**LAKE MANITOBA AND LAKE ST. MARTIN OUTLET CHANNELS PROJECT
RESPONSE TO IAAC TECHNICAL INFORMATION REQUESTS**

Question IAAC-23

QUESTION IAAC-23

Figure IAAC-23-1 A Comparison of Vegetation Conditions before and after Construction of the EOC using a Normalized Vegetation Index (NDVI) Analysis

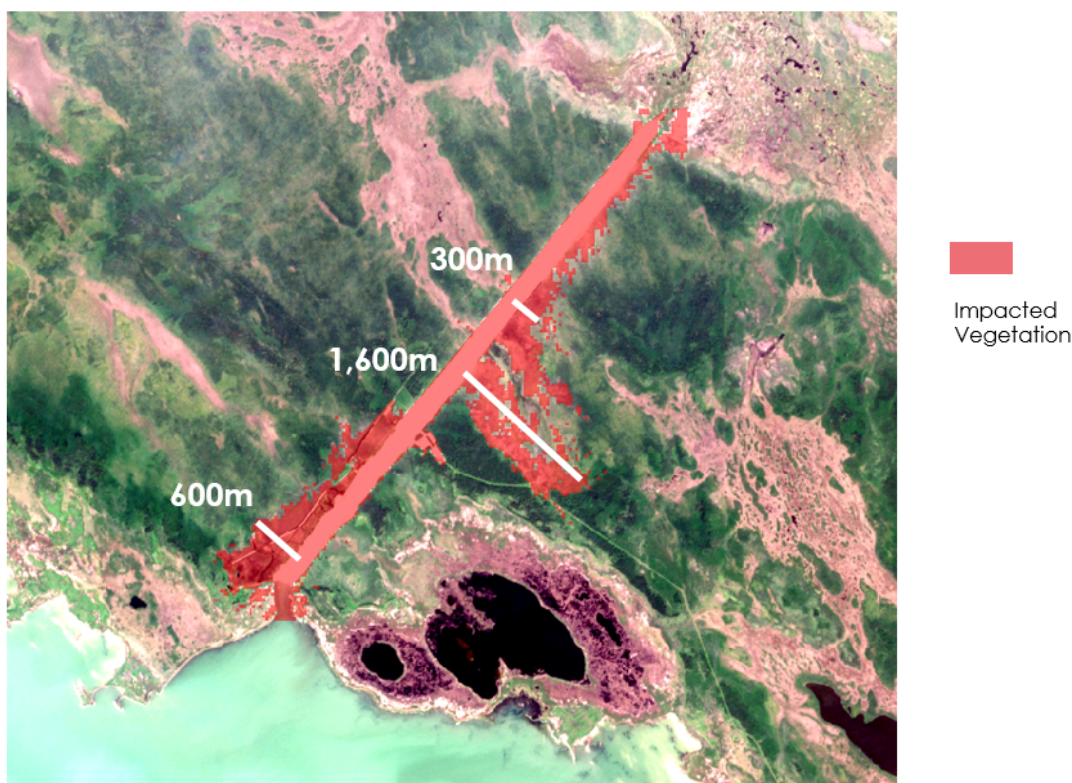
- a) Clarify the potential effects of the construction and operation of the LSMOC on groundwater and surface water interactions, groundwater and surface water quality and quantity, wetlands. Compare these to the effects to water quality and quantity as well as wetlands of the EOC, including details of anticipated similarities, differences, and mitigation. Present analysis and modelling data, where available, to support conclusions drawn and confirm if the changes in water level caused by the LSMOC on the wetland in proximity to the channel are expected to be similar to EOC.

Along the LSMOC, there is no obvious existing drainage network. The assessment of potential catchment area changes in response to the LSMOC construction included an empirical analysis of effects associated with the EOC. The EOC was constructed in the same wetlands complex within the region of the LSMOC. A comparison of vegetation conditions before and after construction of the EOC was done using satellite imagery and a normalized difference vegetation index (NDVI)

analysis (see Figure IAAC-23-1). The analysis compared changes in light reflectance as a measure of plant health and suggested that effects to soil drainage/wetness (using vegetation as a proxy) along the EOC have extended perpendicular to the EOC up to a maximum of 1,600 m upgradient and a maximum 600 m downgradient (these were maximum extents of apparent effects). The areas with darker red noted on Figure IAAC-23-1 are where the vegetation has been affected by the EOC. Although the effect did extend up to a maximum of 1600 m generally, the effects were less than 300 m perpendicular to the EOC. The 1,600 m effect is likely caused by backwater effects from the channel blocking the flow in the wetland causing higher water level and therefore impacting vegetation. These effects due to the presence of the EOC were not mitigated by the design of the EOC because the EOC has no outside drain on the upstream gradient.

The outside drainage that will be designed and built for the LSMOC will prevent a “backwater” effect in the wetland. (see Volume 1, Section 3.4.3.9 Drainage Realignment in the Project Description of the environmental impact statement (EIS) for a description of the outside drain) The drain will maintain water level at natural levels and discharge excess water into the LSMOC. These drainage channels are anticipated to mitigate potential effects associated with “wetting-up” of soils on the upgradient side of the channels. Therefore, the 1,600 m upgradient extent of effects on the EOC are not anticipated to occur on LSMOC and are anticipated to occur over a reduced

distance perpendicular to the channels. The design of a drainage system (i.e., outside drain), will lessen the larger effects seen on the EOC, which had no pre-engineered drainage system. It is anticipated that the larger effects greater than 500 m can be eliminated. For the LSMOC, an upgradient distance of 500 m is considered a conservative estimate considering the implementation of mitigation.

The experience of the EOC indicated that most of the area along the channel is affected for much less than 500 m and often there appears to be no effect immediately adjacent to the EOC (see Figure IAAC-23-1). The total estimated area of effects to LSMOC (1000 m x 24,000 m = 2,400 ha), assumes the entire length of the channels will be affected on both sides to a distance of 500 m perpendicular to the channels. As confidence in this estimate is not high, the conservative estimate, assuming continuous 500 m effects on both sides of the LSMOC for the entire length, has been used.
